RE: ENGINEER CERTIFICATION FOR DIAMOND SHAMROCK AT SECOND AND MENAUL NW,
(H-14/D71) ENGINEER CERTIFICATION STATEMENT DATED 8/26/92

RE: DRAINAGE PLAN FOR DIAMOND SHAMROCK @ SECOND & MENAUL, NW
(H-14/D71) ENGINEER'S STAMP DATED SEPTEMBER 11, 1991

FINAL DRAINAGE REPORT
SECOND & MENAUL CORNERSTORE
NWC SECOND ST. NW & MENAUL BLVD. NW
CITY OF ALBUQUERQUE, NEW MEXICO
SEPTEMBER, 1991

GRADING & DRAINAGE PLAN

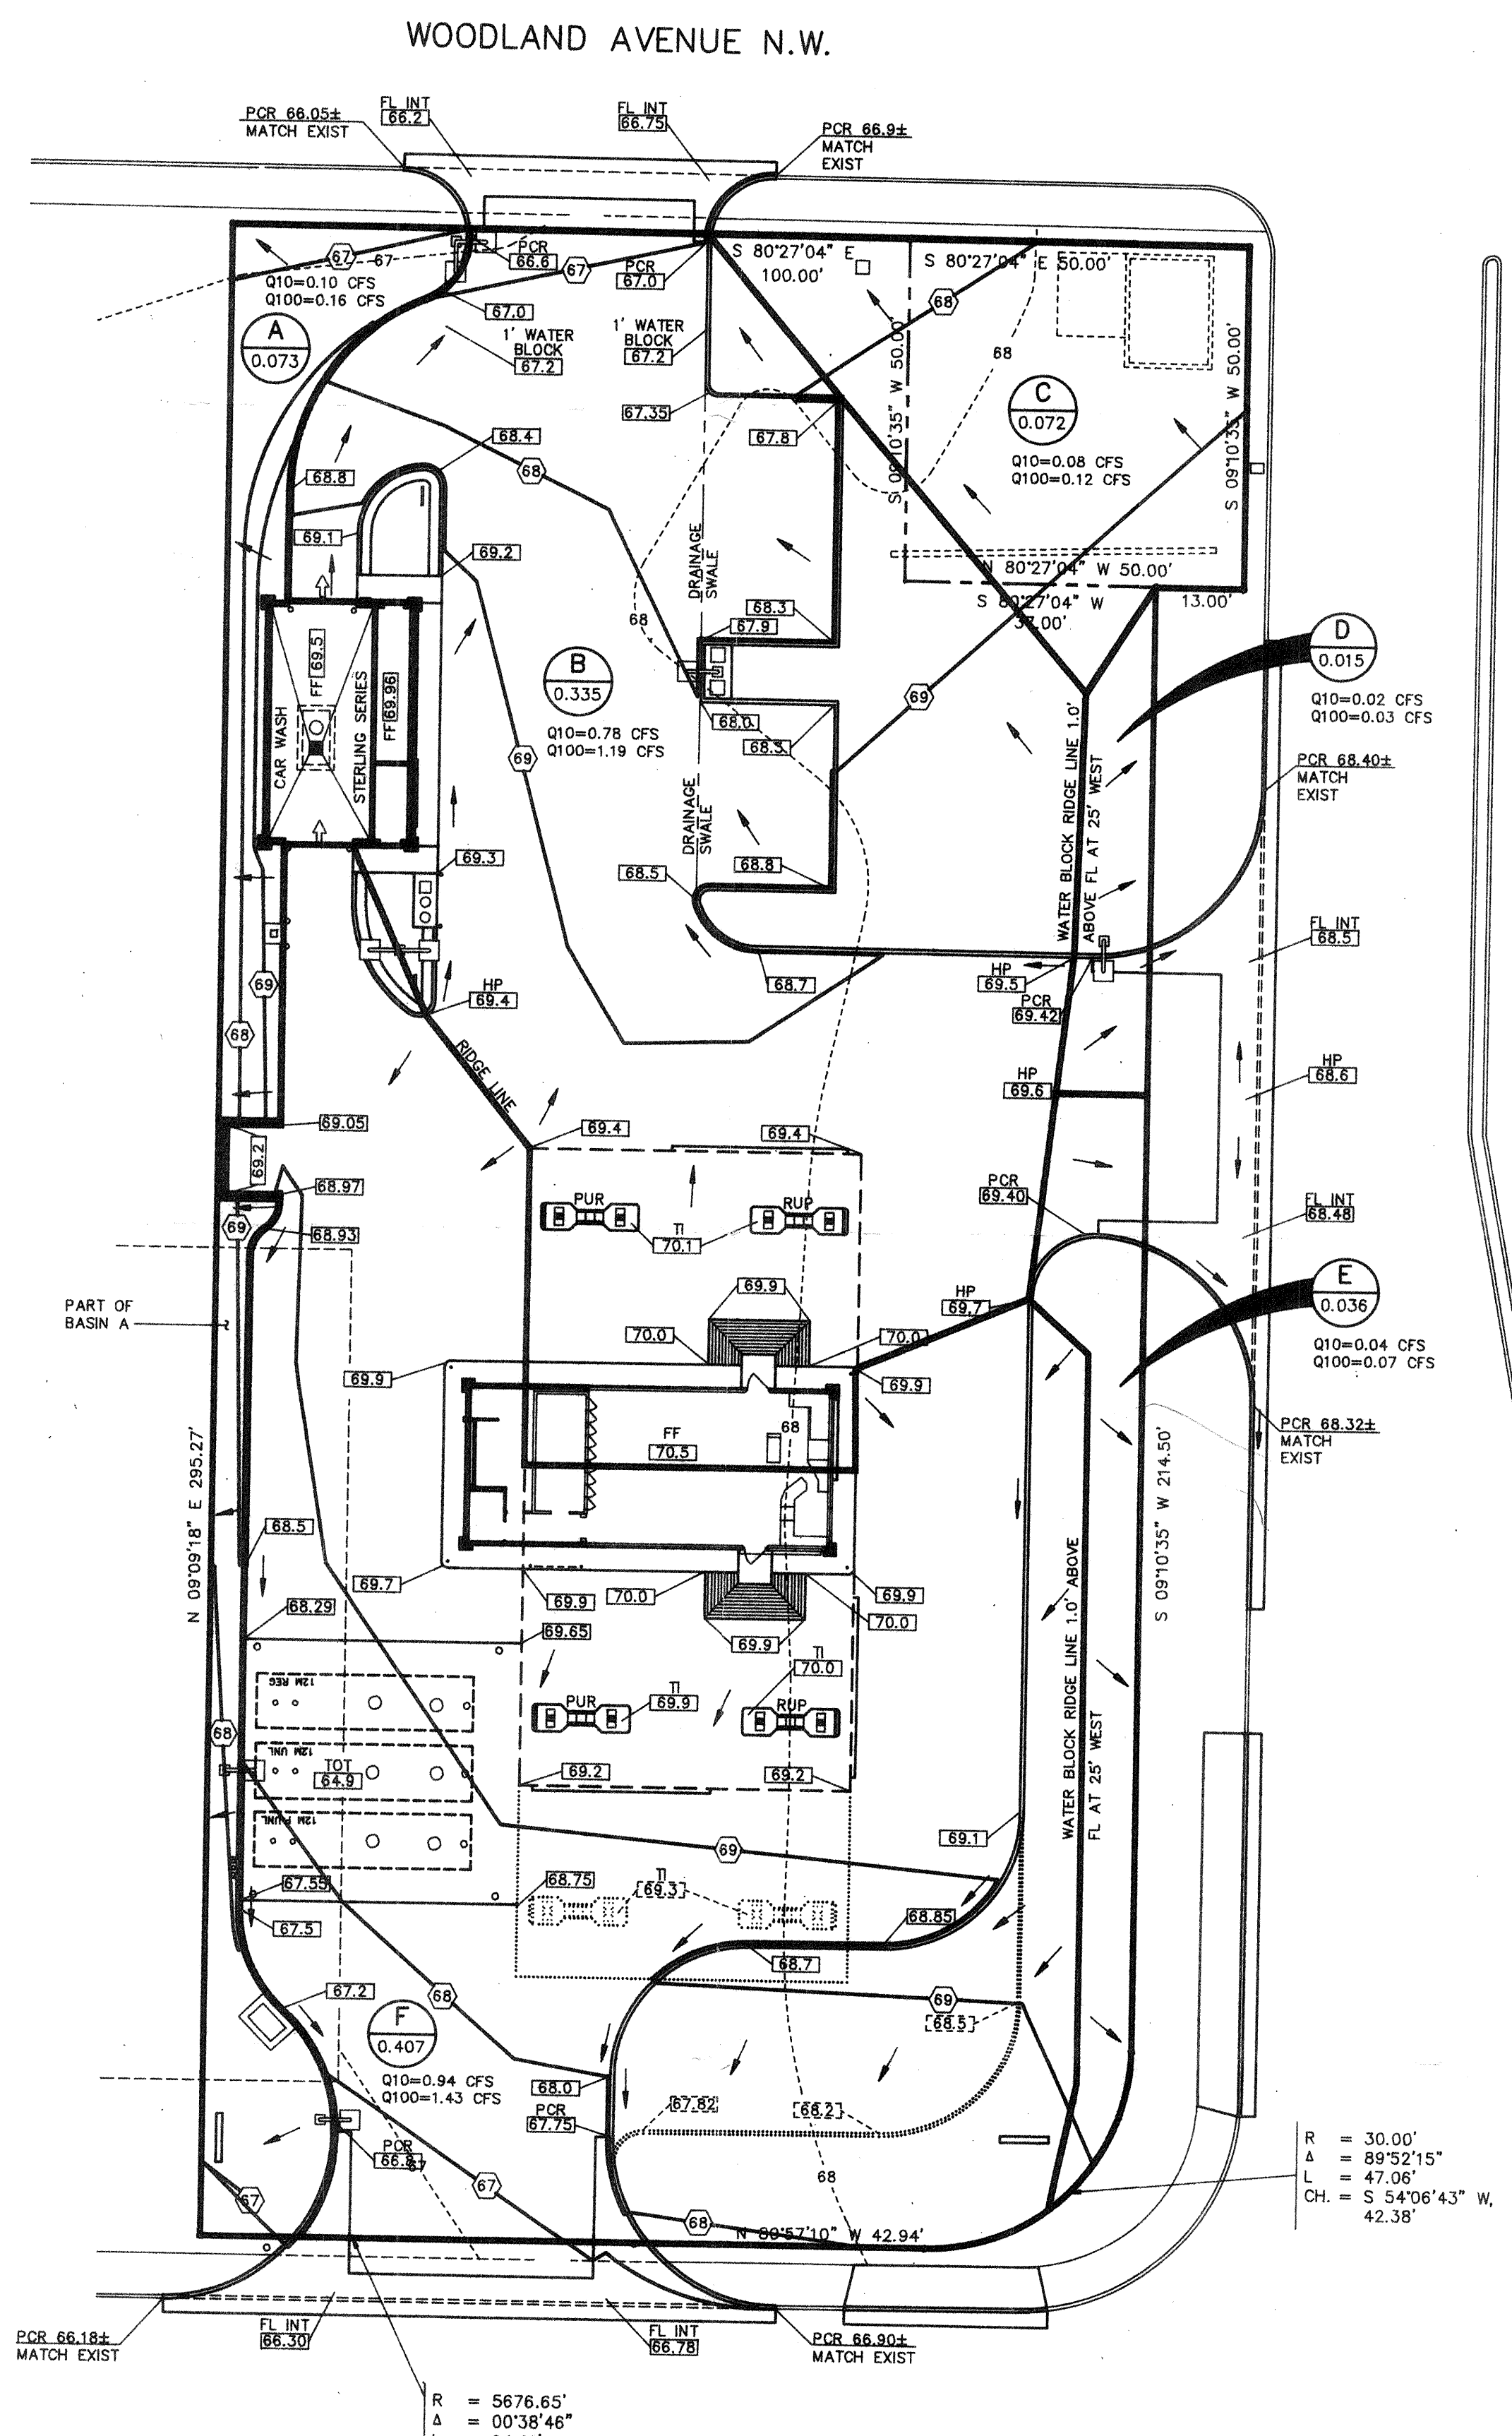
Based on the information provided on your submittal of September 12, 1991, the above referenced plan is approved for Building Permit.

Please be advised that developed runoff is allowed across property lines to the west.

Please attach a copy of this plan to the construction sets prior to sign-off by Hydrology.
